**Swanmore Road
Havant
PO9**

PROPOSED SITE ACCESS & INFORMAL CROSSINGS

STAGE 1 ROAD SAFETY AUDIT

Stage 1 Road Safety Audit Designers Response

Location of problems identified during this Stage 1 Road Safety Audit:

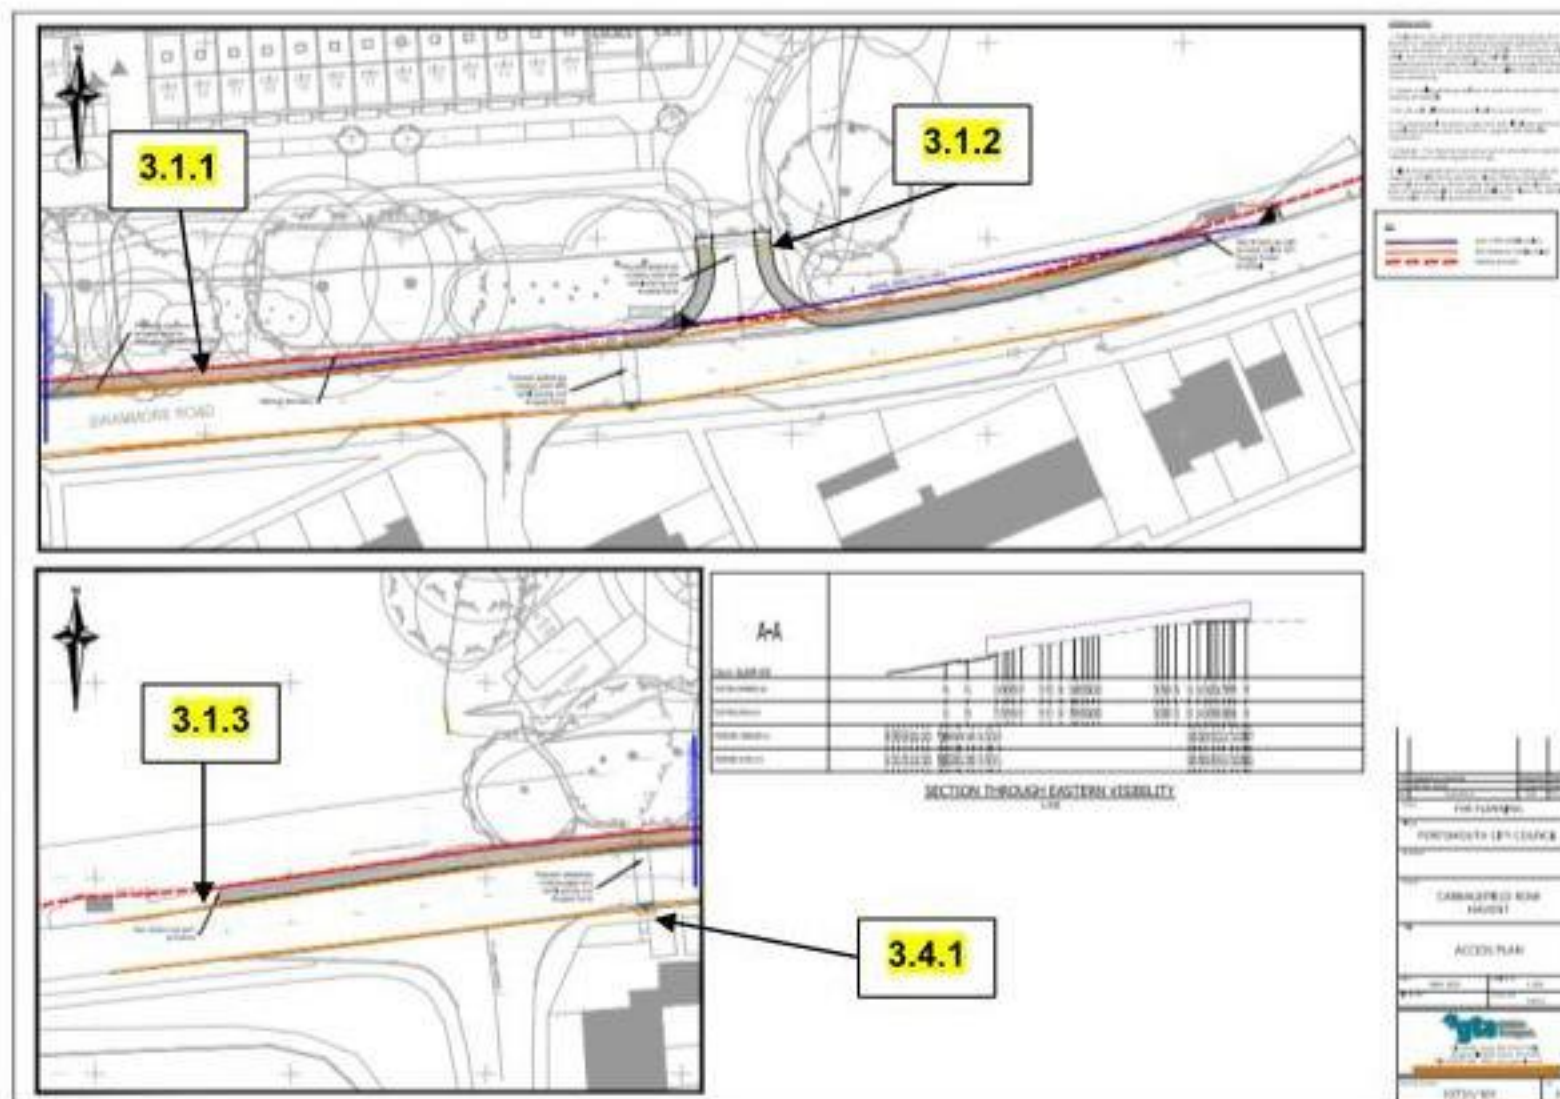
Location: Swanmore Road (northern side)

Summary: Risk of cycle and pedestrian injury due to footway obstructions.

Detail: There are currently various items of street furniture in place where the new proposed footway will be provided. This includes lamp columns, signposts, overhanging vegetation and trees. The shared use path would require a level surface and one without pinch points and obstructions. If these are not relocated to suitable positions, they would be a road safety concern resulting in injury to cyclists or pedestrians.

Location: Swanmore Road site access / junction

Summary: Risk of pedestrian injury due to conflict with vehicles turning into the junction.

Detail: An informal crossing is proposed that is set back into the new access / junction. The tactile paving and pedestrian dropped kerbs will allow pedestrians to cross the new access road. However, this would be located off the pedestrian desire line and therefore it is more likely that pedestrians will cross the mouth of the junction. The informal crossing should therefore be designed with the desire line in mind.

Location: Shared cycle path / footway and existing carriageway

Summary: Lack of continuity for cyclists could result in driver and cyclist conflict and subsequent collisions.

Detail: The plans do not indicate where the existing cycle path (located on the carriageway) will be provided and how cyclists will join the new shared footway. There was concern during the site investigation regarding where cyclists will adjoin the shared cycleway / footway from the existing carriageway. The existing cycle lane appears confusing in various parts and unclear on the expectation for a cyclist using the route. As a result of overall disjointed cycle facilities and confusing continuity, this could give rise to cyclist and driver conflict.

Location: Swanmore Road – proposed informal crossing

Summary: Risk of injury to partially sighted and/or vulnerable pedestrians due to position of steps and lack of warning.

Detail: The proposed informal crossing is located across Swanmore Road, leading from the new northern footway to the existing footway on the southern side. However, this crossing will be placed directly in front of existing steps that lead up from the grass verge and housing estate. Without adequate hazard warning paving or a change in levels, a partially sighted or vulnerable pedestrian could cross the road and whilst trying to position themselves and find the back edge of the footway, trip on the steps and/or change in footway level causing injury.

Footway obstructions to be removed and street furniture to be relocated where appropriate.

Informal crossing / dropped kerbs and tactile paving to be re-positioned closer to the junction access and pedestrian desire line.

Provide sufficient dropped kerbs from the carriageway to the footway to allow cyclists to adjoin the cycle path. Review and extend the designated areas for cyclists to ensure that there is a clear strategy along the entire route.

Additional hazard warning paving should be provided, or the footway level amended accordingly.

3.1.2	Swanmore Road site access / junction	An informal crossing is proposed that is set back into the new access / junction. The tactile paving and pedestrian dropped kerbs will allow pedestrians to cross the new access road. However, this would be located off the pedestrian desire line and therefore it is more likely that pedestrians will cross the mouth of the junction. The informal crossing should therefore be designed with the desire line in mind.	Informal crossing / dropped kerbs and tactile paving to be re-positioned closer to the junction access and pedestrian desire line.	Design amended accordingly, and shown in Appendix H of the TA.

3.4.1	Swanmore Road – proposed informal crossing	The proposed informal crossing is located across Swanmore Road, leading from the new northern footway to the existing footway on the southern side. However, this crossing will be placed directly in front of existing steps that lead up from the grass verge and housing estate. Without adequate hazard warning paving or a change in levels, a partially sighted or vulnerable pedestrian could cross the road and whilst trying to position themselves and find the back edge of the footway, trip on the steps and/or change in footway level causing injury.	Additional hazard warning paving should be provided, or the footway level amended accordingly.	The crossing has been relocated slightly east, and is no longer in front of the steps as shown in Appendix H of the TA.
